TULSA METROPOLITAN AREA PLANNING COMMISSION

For Meeting No. 2486

July 18, 2007

Metro Place, Tulsa County
Preliminary Plat, June 13, 2007
SHEET 1 OF 2

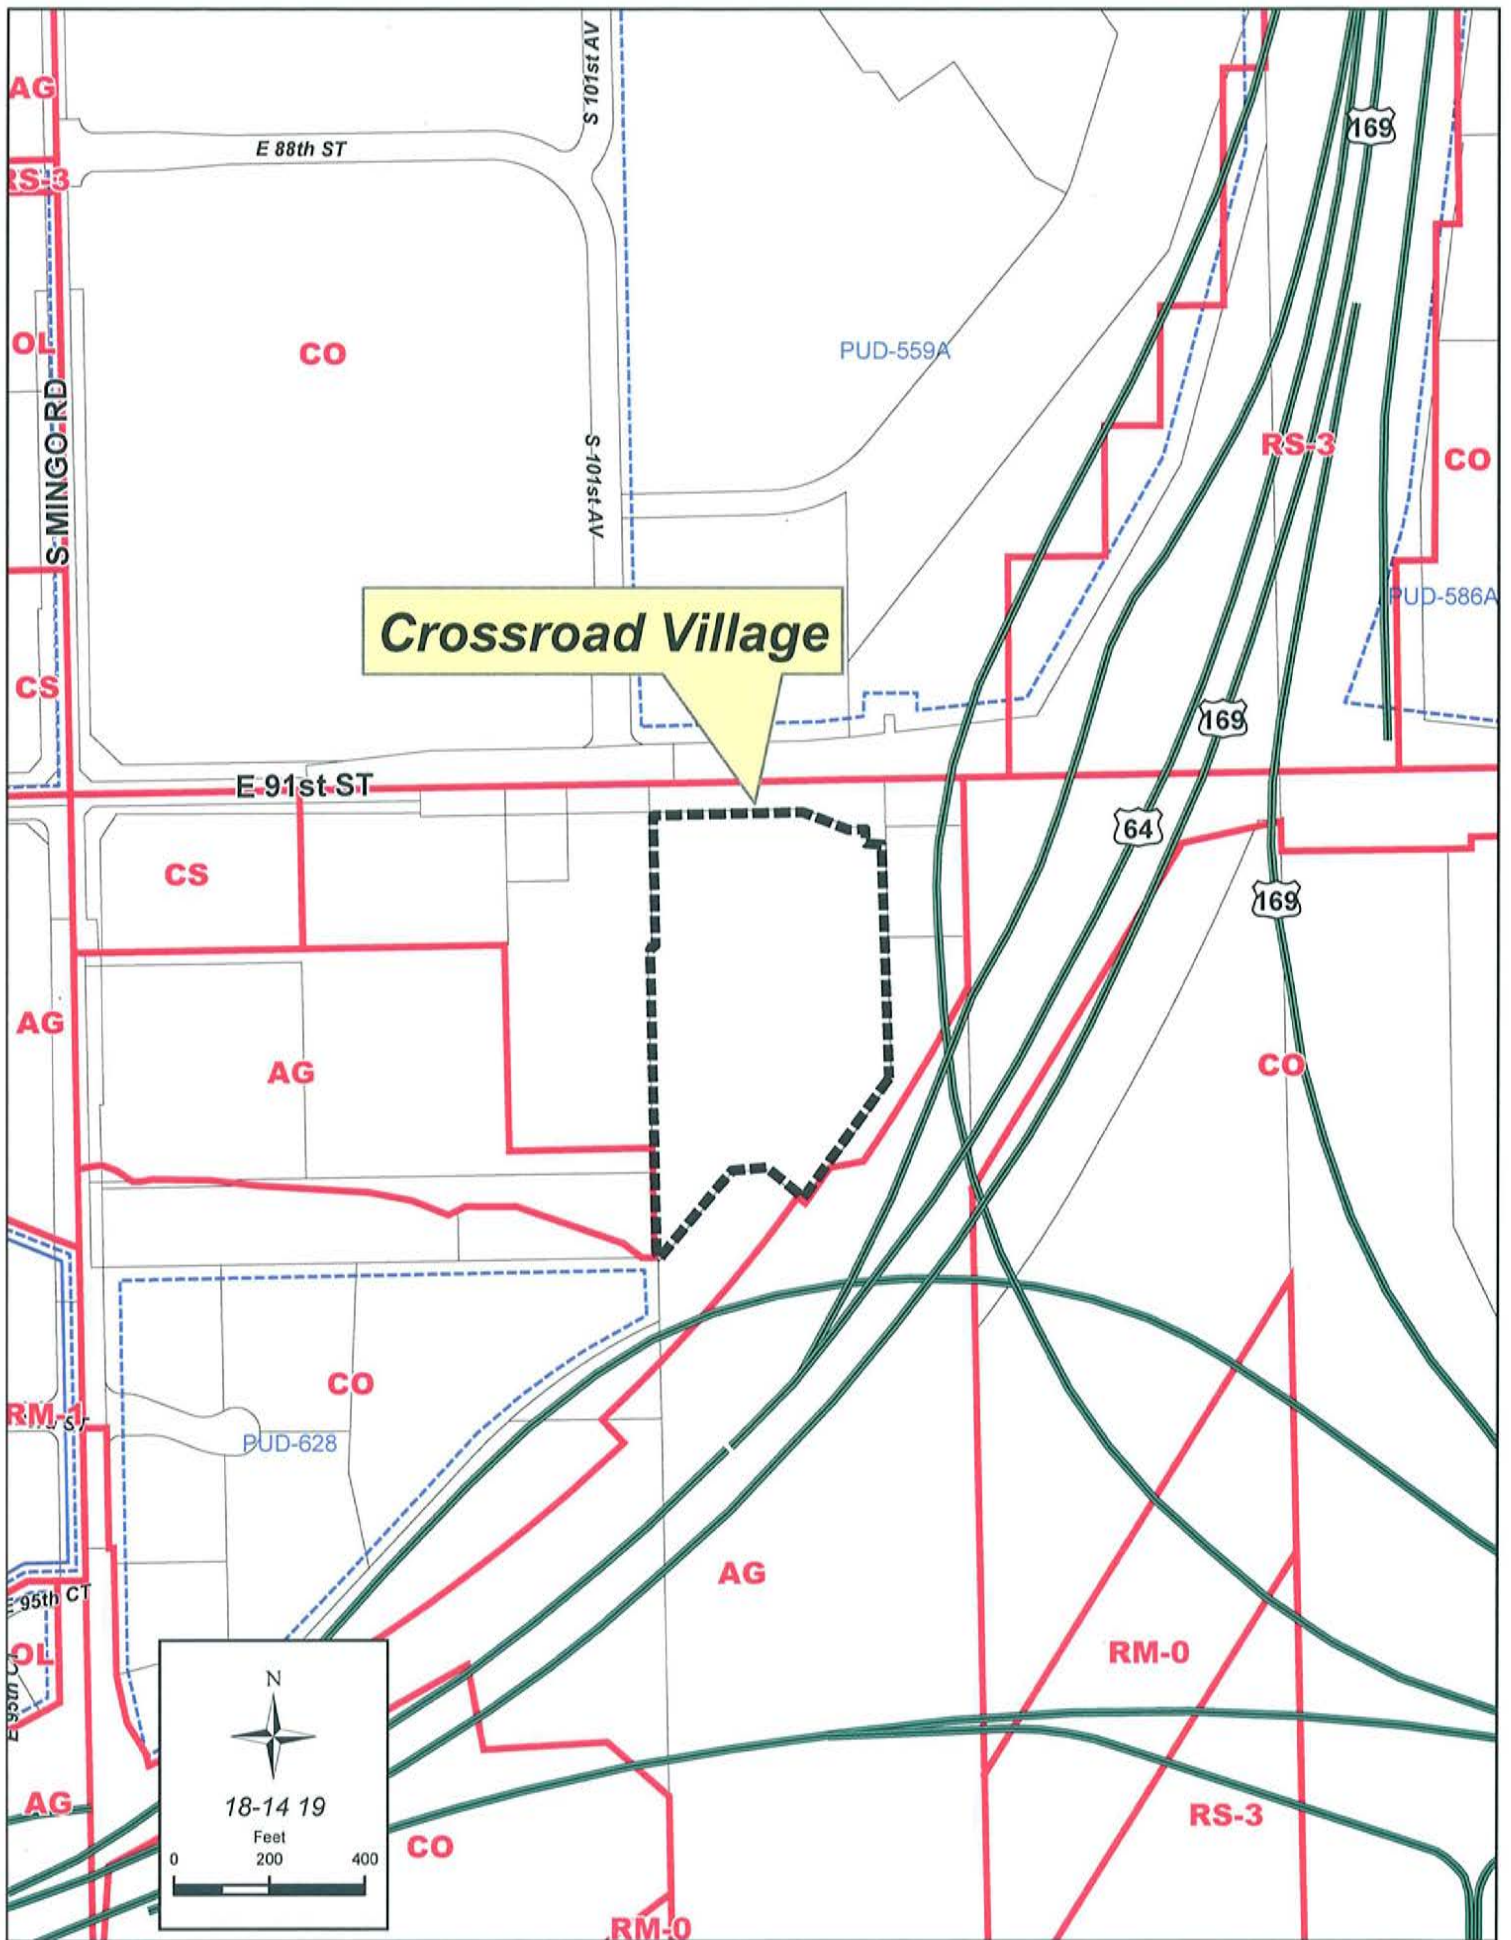
2. **Streets:** Right-of-way dedication needs recording documentation. Section II.B.9. heading should be "Pedestrian.." instead of "Pedestrial.." Revise the LNA from 67 feet to 55 feet to match the proposed drive shown on the conceptual plan. Include standard language for LNA restrictions. Provide for a minimum 15 foot commercial driveway radius; intersect the right-of-way at 90 degrees.

GIS: "Date of Preparation" is the preferred label for date identification on the face of plat. Provide the surveyors e-mail address. Include a tie from a section corner with point of commencement (poc) to a point of beginning (pob) with a metes and bounds description of the property in the legal description.

Crossroad Village, Tulsa County
Preliminary Plat June 14, 2007
SHEET 1 OF 1

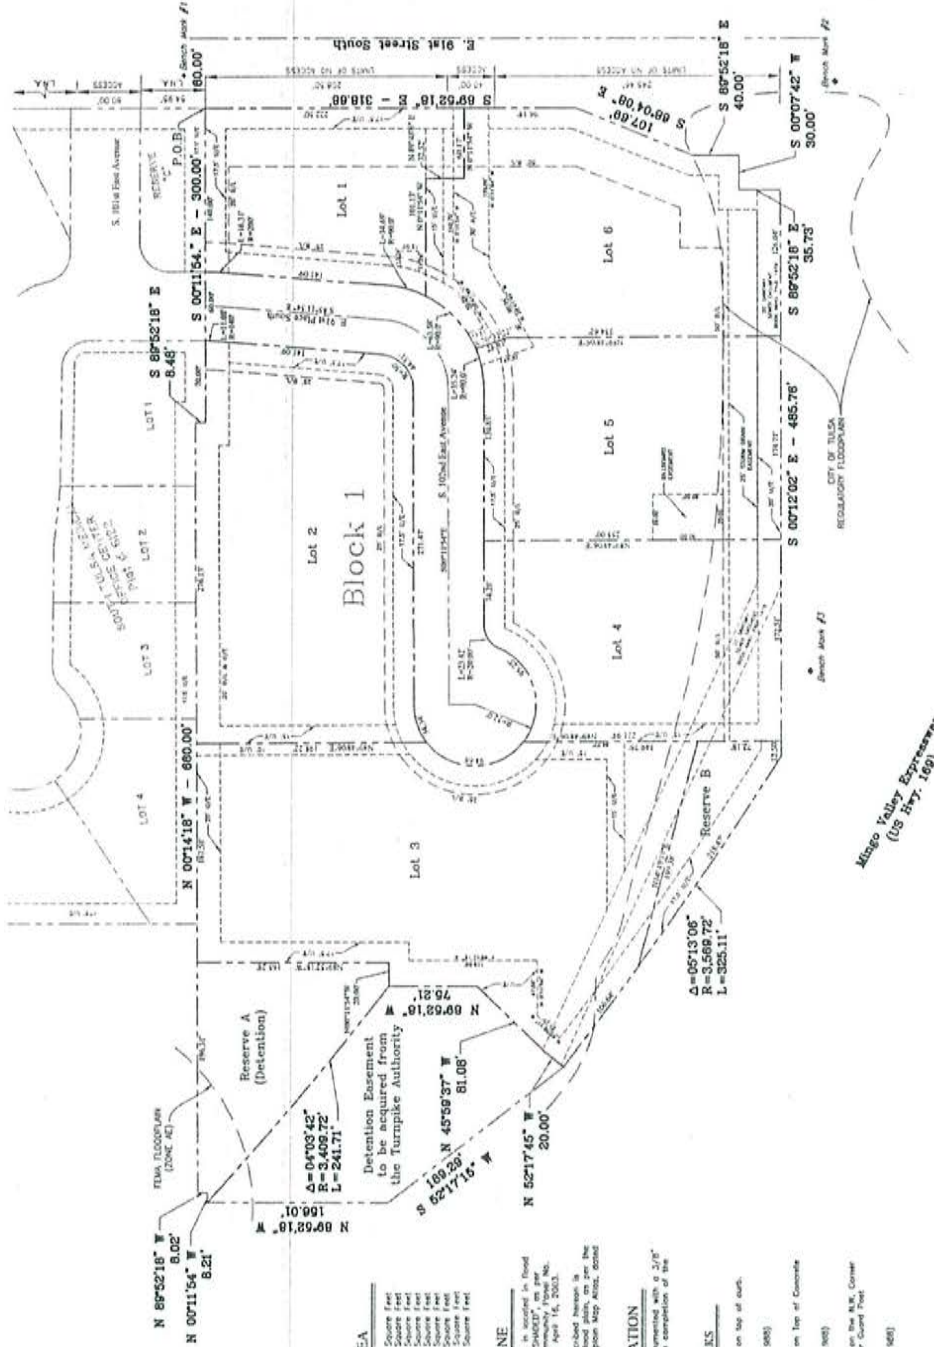
1. **Zoning:** The property is zoned CO-Z-6503-SP2. Reserve A is part of the plat. Streets are public. A trail easement needs to be shown per transportation planner along Reserve A and proposed along the Turnpike Authority easement in the future as land or easements are secured. Covenants need standard trail easement language to be approved by City Legal.

2. **Streets:** City will not accept dedication of the public streets without assurance that the public access tie to 91st Street is constructed on the adjacent proposed plat. Existing right-of-way dedications need recording documentation. Show Limits of No Access along the Mingo Valley Expressway. Delete "general" from Section I.A. Public Streets and General Utility Easements heading. Limits of No Access paragraph needs to include reference to the Mingo Valley Expressway. Dimension the Mutual Access Easement (MAE) from the lot line between lots 1 and 6. Include standard language for the MAE including its maintenance.

5. **Storm Drainage:** Please add "Little Haikey Creek" to both the FEMA and City of Tulsa Regulatory Floodplain labels. For the City of Tulsa Regulatory Floodplain both existing and proposed floodplains must be shown and labeled, and a regulatory map amendment will be required. The easement for the "proposed 10' x 6' RCB" should be labeled as a "storm sewer easement". Add to the label for the "detention easement to be acquired from the Turnpike Authority" the words, "by separate instrument", and begin the label with "stormwater". Please add "stormwater" to the portion of the Reserve A label, that is in parentheses. If it is the owners' intent to construct a portion of the stormwater detention facility in the FEMA floodplain, then a Certified Letter of Map Revision (CLOMR) must be approved prior to the commencement of any construction in this addition. If not, then the FEMA floodplain should be placed in a separate reserve for overland drainage. Unless a CLOMR is being done, add the reserve for the FEMA floodplain to the title for Section I.I. Please revise the language in this section by using

the standard language for Reserve area and overland drainage easements for floodplain areas. Add the standard "prorata" language to section I.H.6.

6. **Utilities: Telephone, PSO, ONG, Cable:** More utility easements will be needed.
7. **Other: Fire:** No comment. Number the lots either clockwise or counterclockwise. Lot lines need to be different line style (weight and type) from plat boundary lines. Legal description should include a metes and bounds description of the combined tracts so that it replicates the final platted property boundaries shown on face of plat.

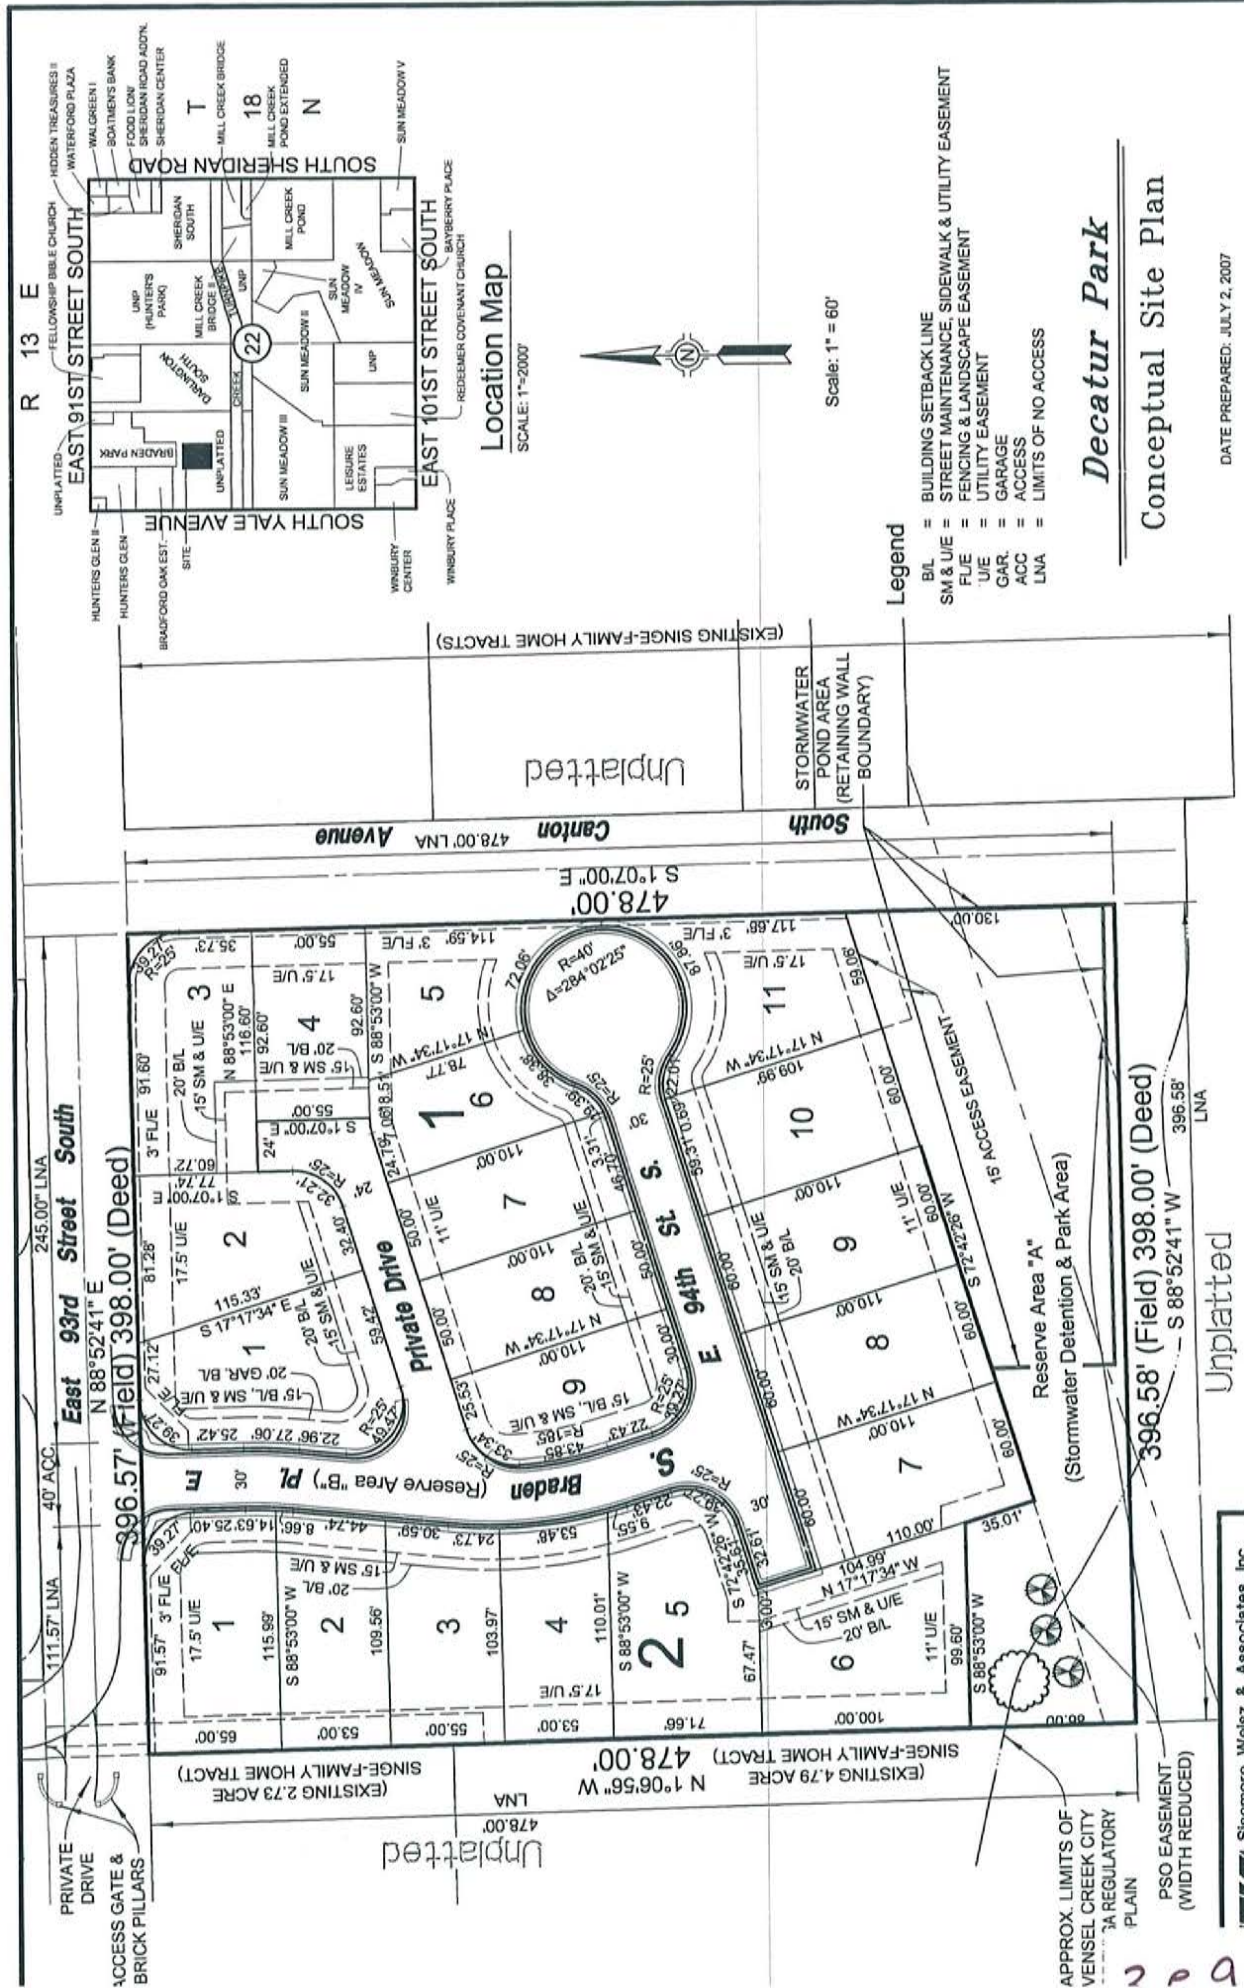
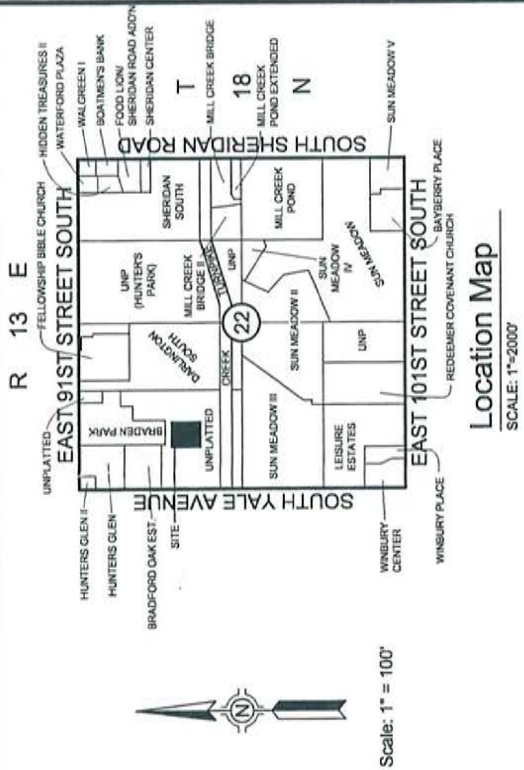
Wastewater: Sanitary Sewer service must be provided to all proposed lots.

Transportation: The "Private Drive" cul-de-sac should be curbed and guttered to meet City of Tulsa standards.

A stub street to the west, to provide non-arterial access for the adjacent 4.79 acre tract's future development, is not being proposed, and as stated in the May 17, 2007 TAC Comments, the PUD as proposed " . . . would force future street access with a cul-de-sac or loop system from S. Yale." In this regard, constructing an intersection on the east side of S. Yale for that tract's development may not be economically feasible in the future due to topography and recent upgrades to S. Yale Ave. Within the public right-of-way adjacent to that tract's frontage on S. Yale, a 194 ft. long retaining wall extends from a point just north of the westbound Creek Turnpike exit ramp to a point about 112 ft from the north property line of the 4.79 acre tract. The wall was constructed as part of the 91st and South Yale Ave. improvements to support sidewalk and roadway engineered fill and paving. It ranges in height from 4 ft at the ends to 13.5 ft at mid-section, with a 3.5 ft high handrail on top for the full length. Proper side street separation on S. Yale Ave. from the next nearest intersection (the 94th St. S. private street access to Ashton Woods on the west side of Yale) would require an east side street access centerline to be about even with the north end of the retaining wall. Considerable redesign, re-grading, and reconstruction of the retaining wall system's north end would be required to accommodate what would be a right-in and right-out only access road at that location on the east side of S. Yale.

Traffic: Provide construction standards for the private streets per the Sub. Regulations within the PUD's Development Standards.

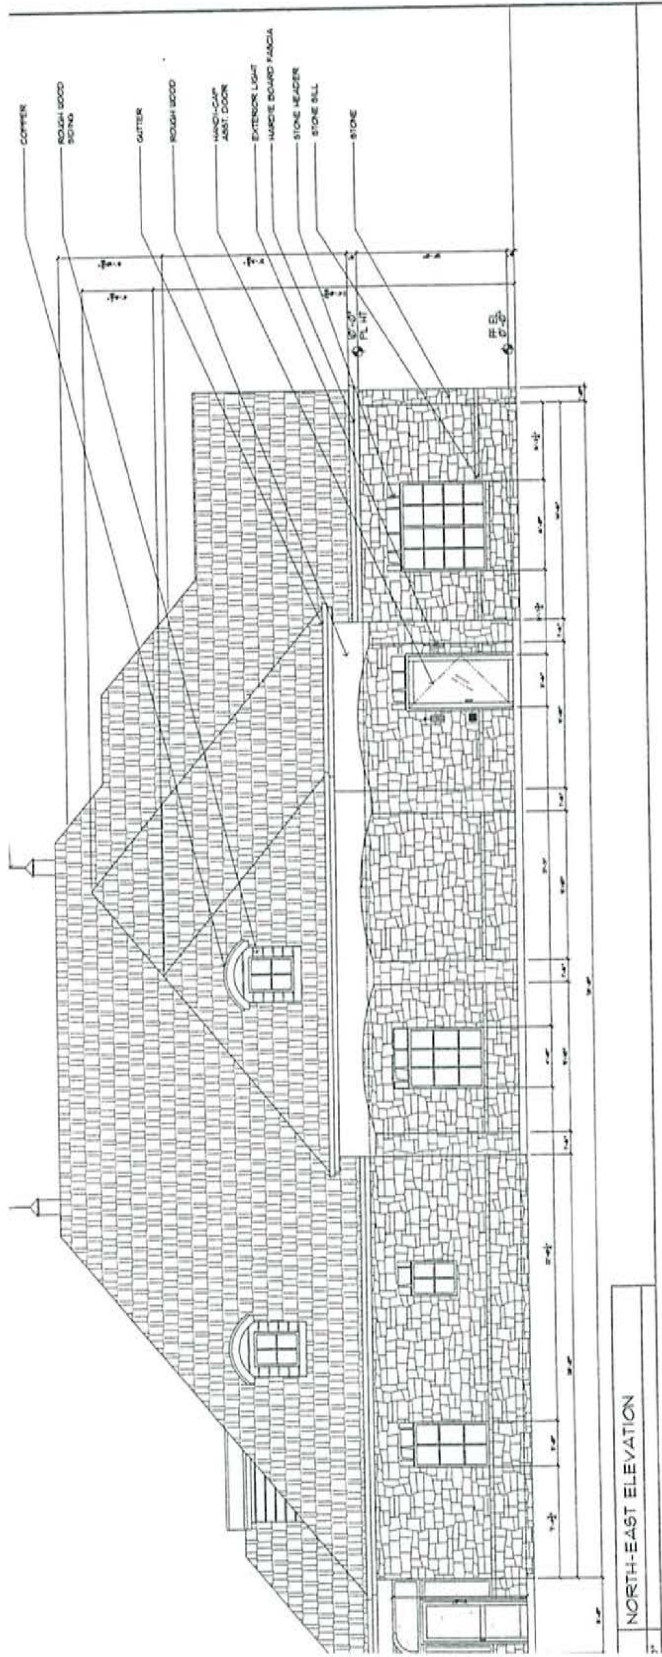
The proposed design of parking and access are awkward. Two access drives located on the same frontage, South Toledo Avenue (which provides sole access to an eighty-five lot single-family residential development immediately adjacent to the south), are 23 feet apart with the northernmost drive being 20 feet from the intersection of South Toledo Avenue and South Toledo Court. To reduce potentially conflicting turning movements, staff recommends that only one access be permitted onto South Toledo Avenue.

In addition, a single bay of parking along with a 24 foot parking aisle is proposed on the west side of the building immediately adjacent to the west property line. The parking lot must be set back a minimum of three feet from the west property line to allow room for overhang of vehicles. Also, provision for mutual access between the proposed site and adjacent lots to the west is recommended in accord with the restrictive covenants of the Ashton Creek Office Park plat.
